Regulation No. 43 (Safety glazing)

Proposal for draft 01 series of amendments to Regulation No. 43

Submitted by the expert from the European Association of Automobile Suppliers*

Glass-plastic panes other than windscreens

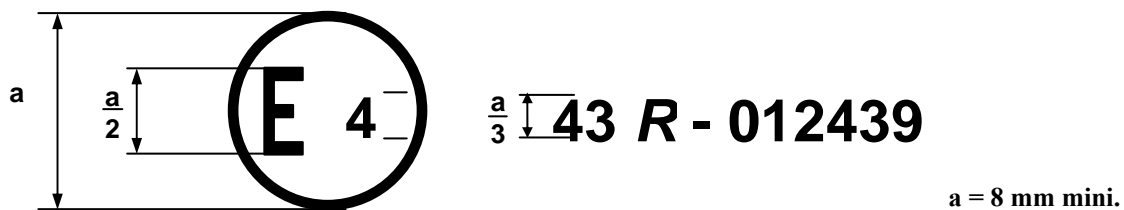
Insert new paragraphs 5.5.9. and 5.5.10., to read:

“5.5.9. XII in the case of glass-plastic panes other than windscreens.

The above approval mark affixed to glass-plastic pane other than a windscreen, shows that the component concerned has been approved in the Netherlands (E 4) pursuant to Regulation No. 43 under approval No. 012439. The approval number indicates that the approval was granted in accordance with the requirements of Regulation No. 43, as amended by the 01 series of amendments”

Support for ball tests

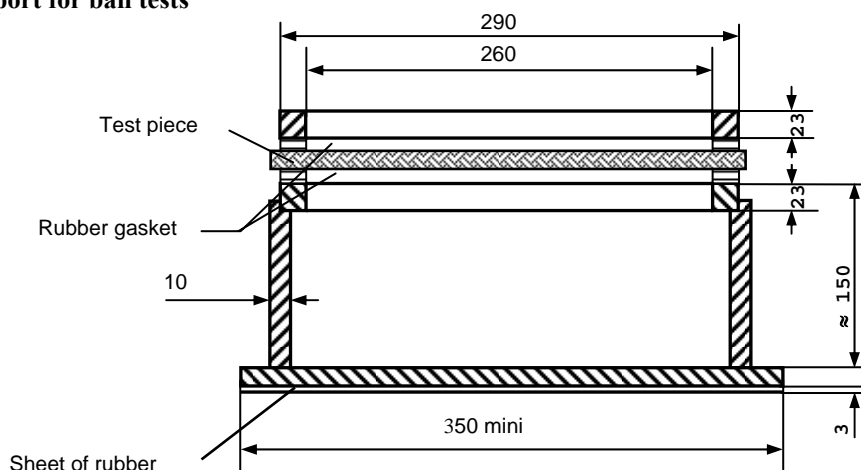
Paragraph 2.1.1.3, figure 1, amend to read:

Figure 20: Sample

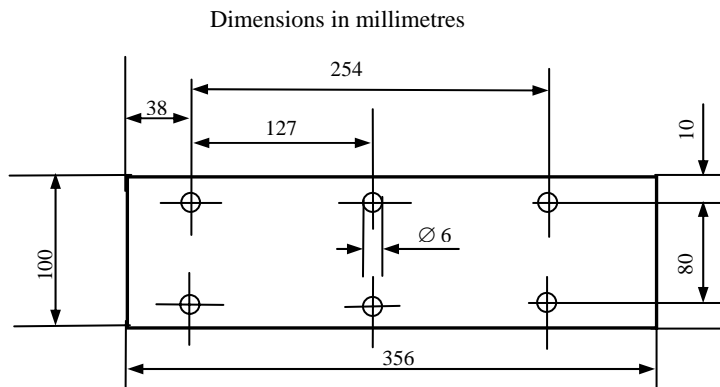
Paragraph 10.5.1., figure 20, amend to read:

Prescribed points of impact for uniformly toughened glass panes

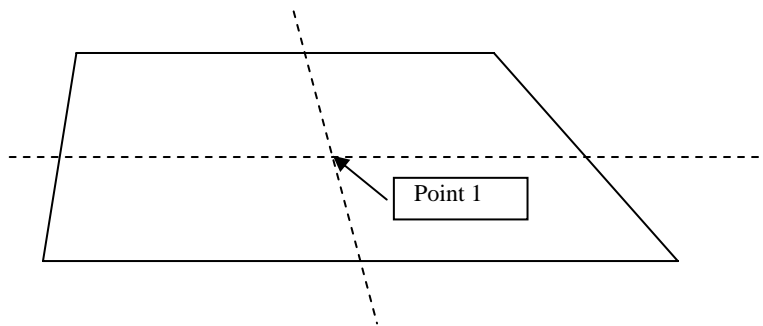
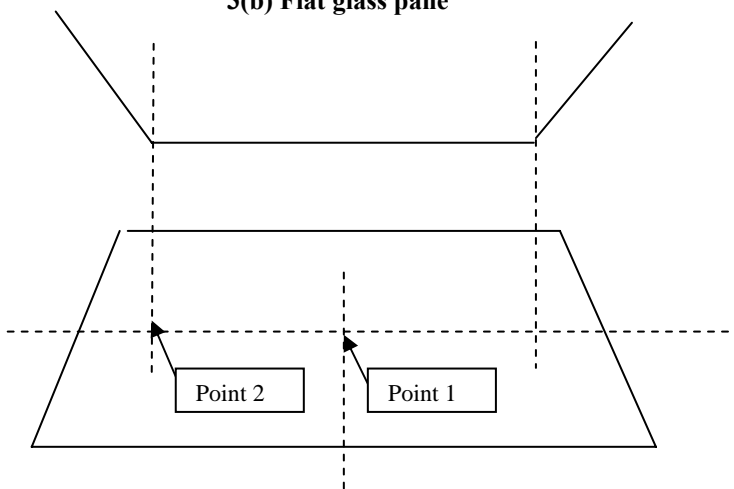
Annex 17, figure 3, amend to read:

“2.5.1. For flat glass panes and curved glass panes the points of impact represented respectively in Annex 17, figures 3(a) and 3(b) on the one hand, and in Annex 17, figure 3(c) on the other hand, shall be as follows:

Point 1: In the geometric centre of the glass.

Point 2: For curved glass panes having a minimum radius of curvature “r” of less than 200 mm. The point shall be selected on the largest median in that part of the pane where the radius of curvature is smallest.”
